12/21/01
Septic tank replacement
12-1

ISSUE DATE: 12/13/2001

ON-SITE SEWAGE DISPOSAL SYSTEM HOWARD COUNTY HEALTH DEPARTMENT BUREAU OF ENVIRONMENTAL HEALTH

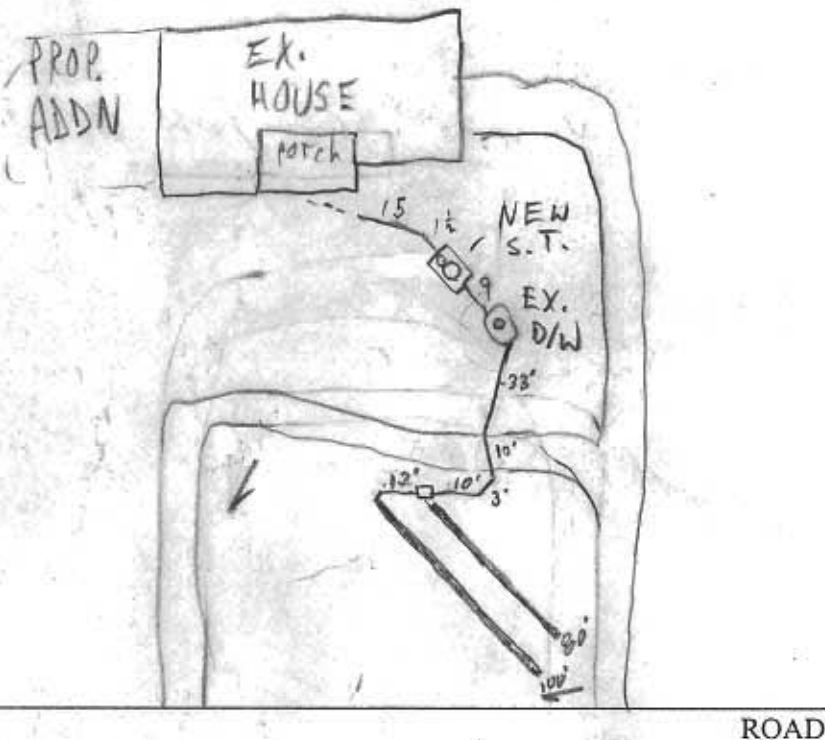
PRE-CONSTRUCTION 12/21/01 CONTRACTOR/OWNER NOT AWARE OF TRENCH REQ'MENT TO BE INSTALLED AFTER REVIEW W/BLDR; EX. D/W FULL, COMPLETE 5BR SYSTEM REQ'D ME/KE

INSTALLATION 1/2/02 - OK TO COVER TO D. BOX, RUN 2 - TRENCHES ON CONTOUR Y/ANNE

AS PER PREVIOUS INSTRUCTIONS - (SRK/50) 1/3/02 OK to cover all work (SC)
